Re: Frontier's Response to Riverside County East Service Area Audit Report

Frontier California Inc. (U-1002-C) and Frontier Communications of the Southwest Inc. (U-1026-C) collectively referred to as ("Frontier") hereby responds to the March 19, 2025, California Public Utilities Commission (Commission) Frontier Riverside County East Service Area Communications Infrastructure Provider (CIP) Audit Report.

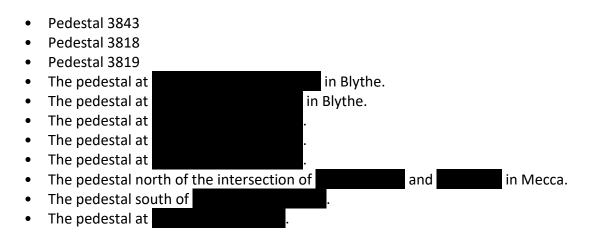
The locking mechanism on each of the following underground structures was broken:

- Pedestal 3843
- Pedestal 3818
- The pedestal near in Blythe.
- The pedestal south of in Mecca.

• The Handhole east of the intersection of	and	in Mecca.
A pedestal on the southeast corner of its cover.	and	in Mecca was missing
The housing of the pedestal at	was damaged.	
The pedestal north of the intersection of due to dirt and debris built up around its base.	and	could not be closed

**Response:** Tickets have been issued to resolve nonconformance. See attached "Frontier Riverside County East Audit Tickets.xls".
